TECHNICAL NOTE			
from:	ALAN DAVIES	date:	28/3/2022
subject:	Land at the North of the Chapel Hill site Longridge for the erection of 4no. commercial units (Use Class E).	file ref:	J1354-TN1A

This Technical Note sets out the response to the feedback as an addendum in rev A in red for ease of reference.

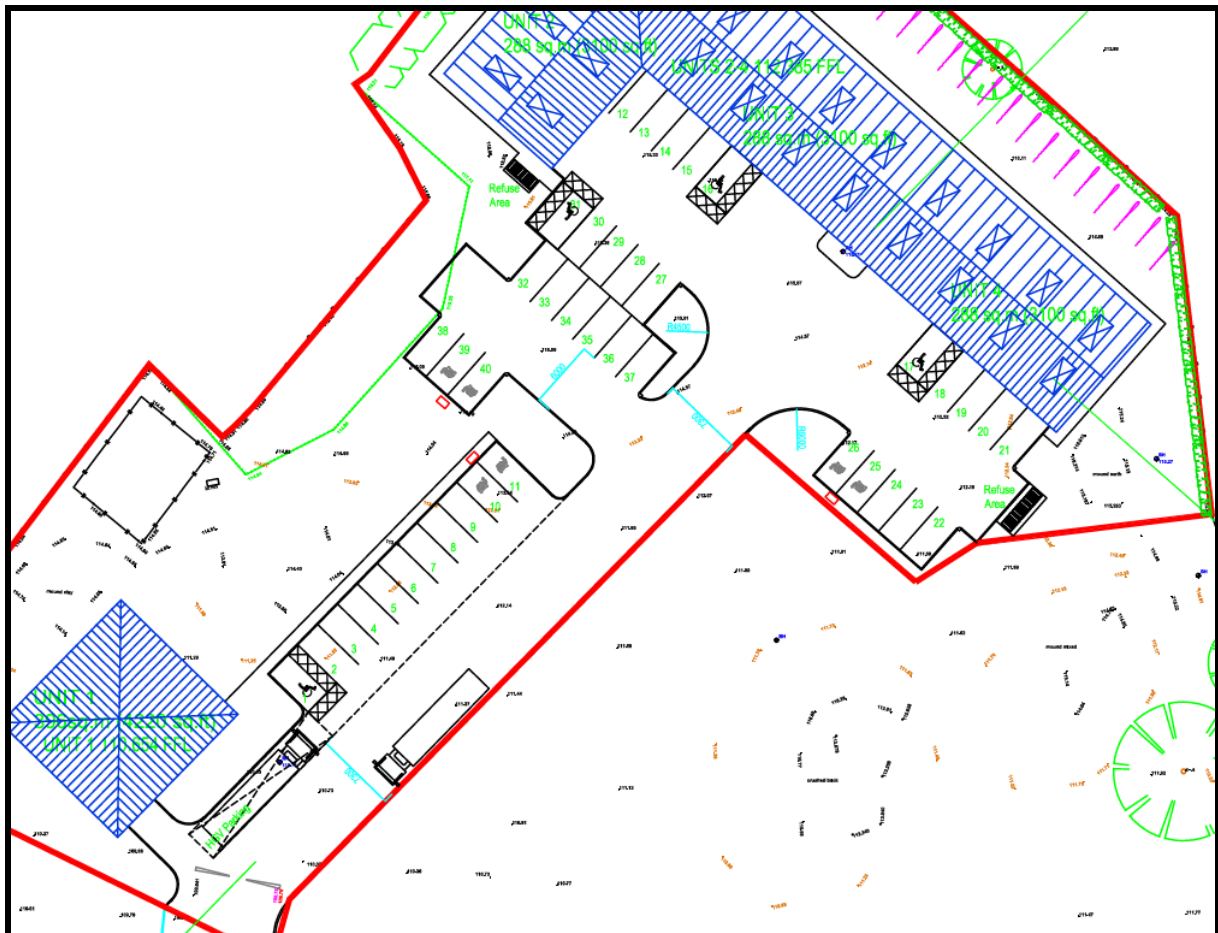
The LHA have reviewed IP drawing number 3 Rev B titled "Plans and Elevations As Proposed" and are aware that the site will provide 30 car parking spaces for the proposal. This however does not comply with the parking standards found in the Joint Lancashire Structure Plan, which requires a B1 development in Longridge with the internal floor area of 1256 square metres (sqm) to provide 40 car parking spaces.

It is worth noting that the LHA are aware that the site is in close proximity to bus stops which serve services to Preston and the Longridge area. However, should visitors to the site travel from outside these areas, the most likely mode of travel is by vehicle leading to the need for further car parking spaces to serve the site. Therefore, the LHA require the additional 10 spaces to enable the site to comply with the LHAs guidance. This should be shown on a revised plan.

The parking offered was based on location and operational needs of the site which is based on the national policy framework, the increase to 40 to meet the maximum policy levels ignores this however the extra 10 spaces are shown on the revised drawings and the abstract below.

Spaces 37 to 40 will be designed as overspill spaces i.e. crushed stone construction to be used if and when needed.

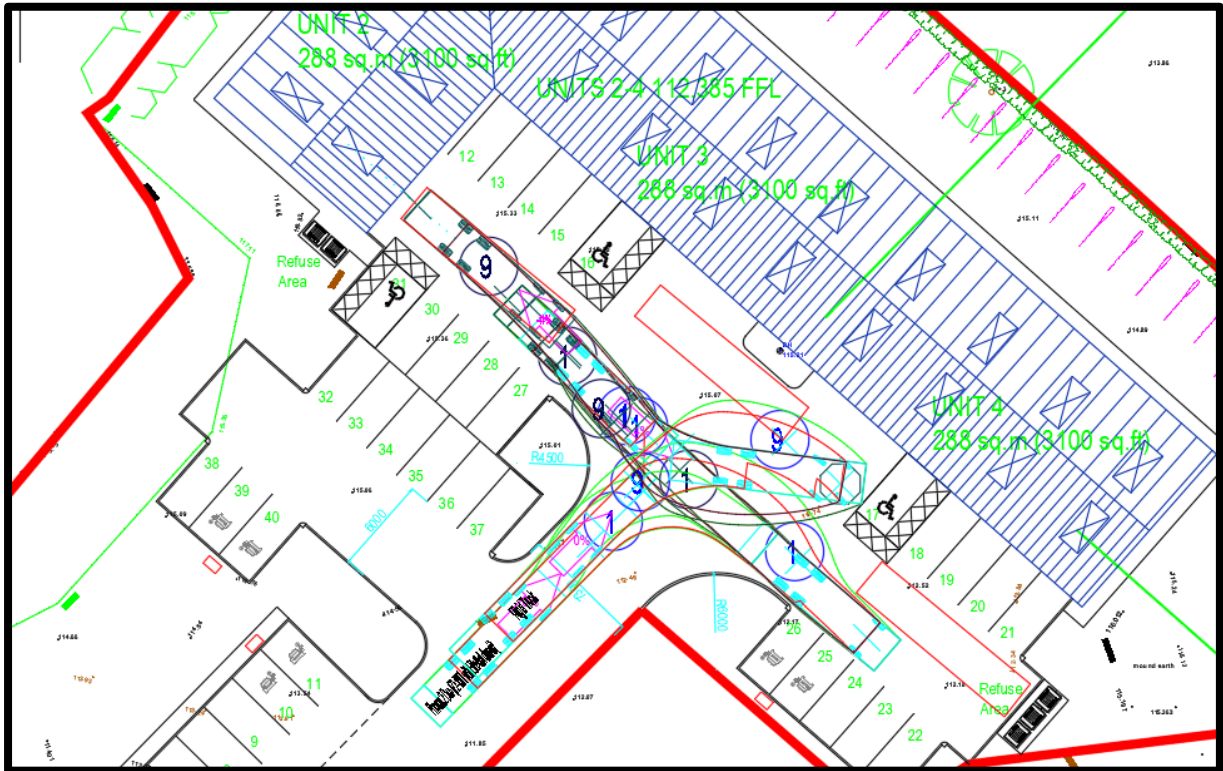
The LHA also require on the revised plan a loading area for Unit 1. This is because currently there is no area for servicing for Unit 1 and so the LHA are concerned that any servicing vehicles will block the use of the internal road into and out the site. The LHA advise that the area should be located adjacent to the Unit,

The dimensions of the loading area should be a minimum of 2.4m x 15m as a guide to enable Heavy Good Vehicles (HGV) to use the space but the LHA will require a tracking drawing to ensure that the proposed dimensions are adequate

The LHA require the space to be large enough for an HGV to use because there is a lack of designated areas for HGVs to park within the site. Not only this but should an HGV or another delivery vehicle be servicing one of the other units, the area can then be used as a waiting area until the vehicle exits the site.

A maximum rigid vehicle of 12m has been tracked for the revised internals, the spaces are designed to accommodate the size of vehicle and other than at unit 1 no requirement to mark out as they form the aisles etc.
